Regional Review Finding Development of Regional Impact

RE: Development of Regional Impact (DRI) Review

Name of Proposal: Stream Data Center DRI 4334

Description: A DRI review of a proposal to construct a data center with 2,687,400 SF of space in 9 buildings along with 2 substations and supporting facilities on a 275-acre currently wooded site with multiple streams on Jason Industrial Parkway in Douglas County. The review period was extended due to the need to correct the initial SF reported from 1,343, 700 SF to 2,687,400 SF.

**DRI - METHODOLOGY MEETING
 PACKET SITE PLAN**

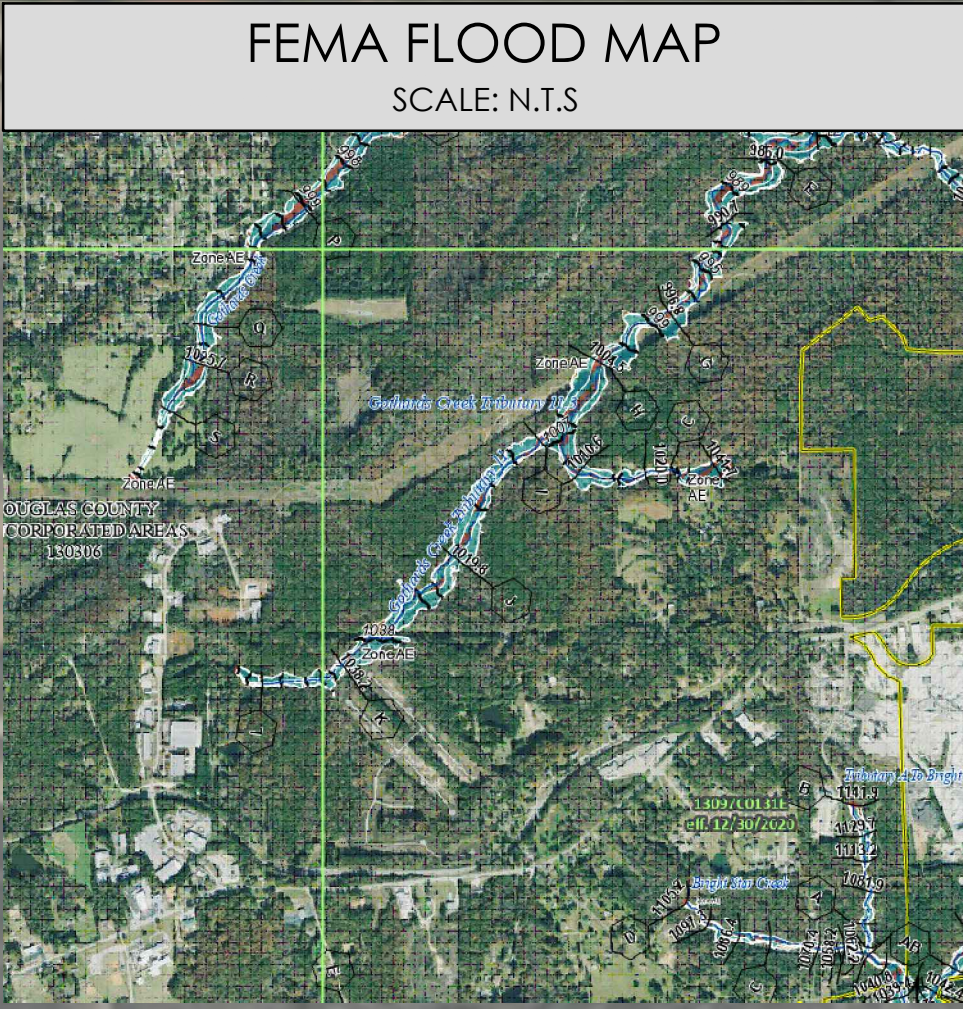
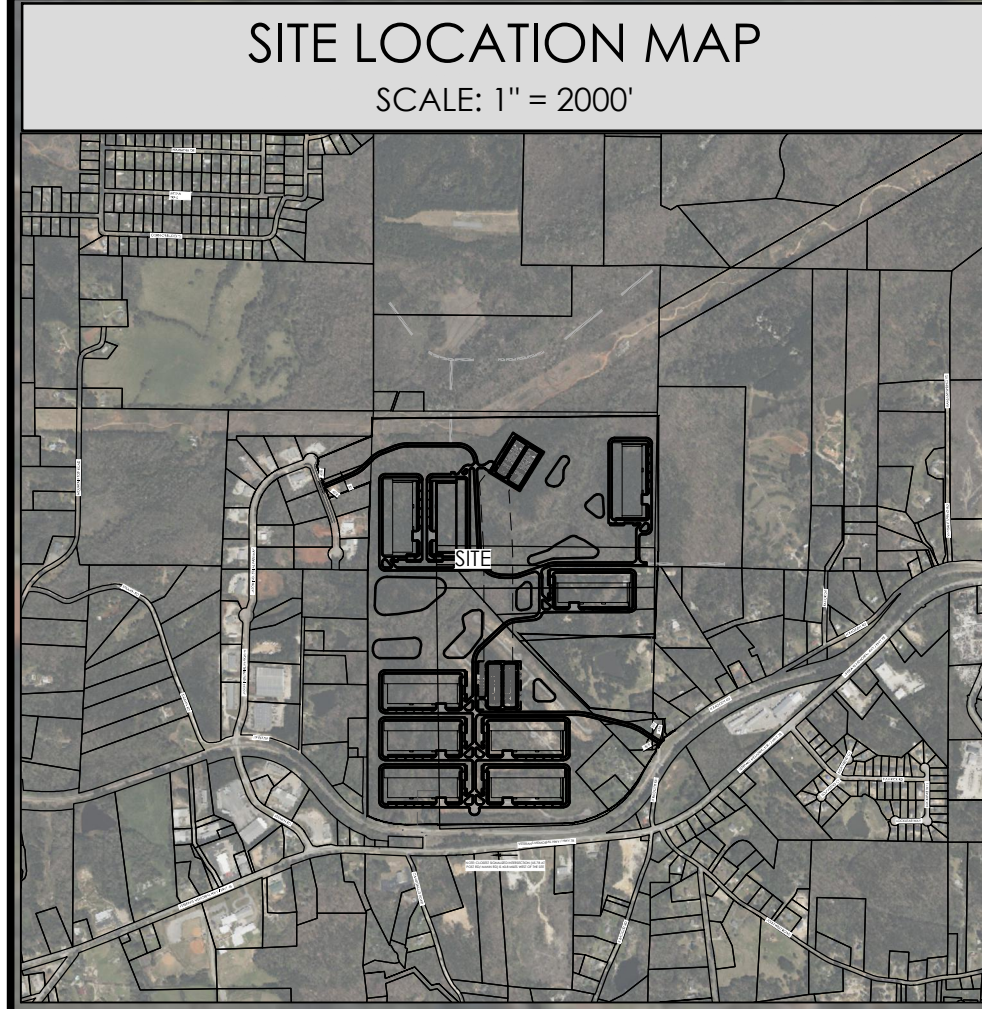
Construction of large portions of the project - including all of buildings 3,4,6 and 7 - will require destruction of large areas of protected streams which will require stream buffer variances as well as USACE wetlands mitigation.

The USGS coverage for the project area and the submitted site plan both show an unnamed blue-line tributary of Gothard's Creek, which in turn is a tributary to Sweetwater Creek, crossing the property from the center of the west side of the property then flowing to the northeast. The site plan also shows three tributaries to the unnamed stream, with the southernmost having two branches off its main stem. The project is within the Douglas County Sweetwater Creek watershed. Under the county Unified Development Code (UDC), both the watershed criteria and the stream buffer criteria require a 75-foot impervious surface setback and a 50-foot undisturbed buffer on all "regulated" streams. Under the County UDC Section 903(b), all blue line streams are regulated streams. The submitted site plan shows the County's 75-foot impervious setback and 50-foot undisturbed buffer, as well as the 25-foot State Sediment and Erosion Control buffer, on all streams shown on the property. The only intrusion shown on the blue-line stream on the submitted plans is a transportation crossing, which is allowed under the County Code. However, the plans show construction within buffers and over streams on all of the tributaries to the unnamed blue line stream, particularly the southernmost tributary with branches – the site plan shows four buildings, parking areas and several roads sited on top of one or more stream channels, with a proposed substation and other roads intruding into the buffers. Less extensive road, parking area and building sites intrude into the buffers on the two other tributaries.

The FEMA coverage for the project area shows 100 -year floodplain along the unnamed blue-line stream. The FEMA floodplain is shown on the proposed site plan and no intrusions other than one transportation crossing are shown on the plans.

657 PROPOSED EMPLOYEE SPACES < 1075 REQUIRED MINIMUM SPACES
 IT IS ANTICIPATED THAT A PARKING VARIANCE WILL BE REQUIRED FOR THIS SITE.
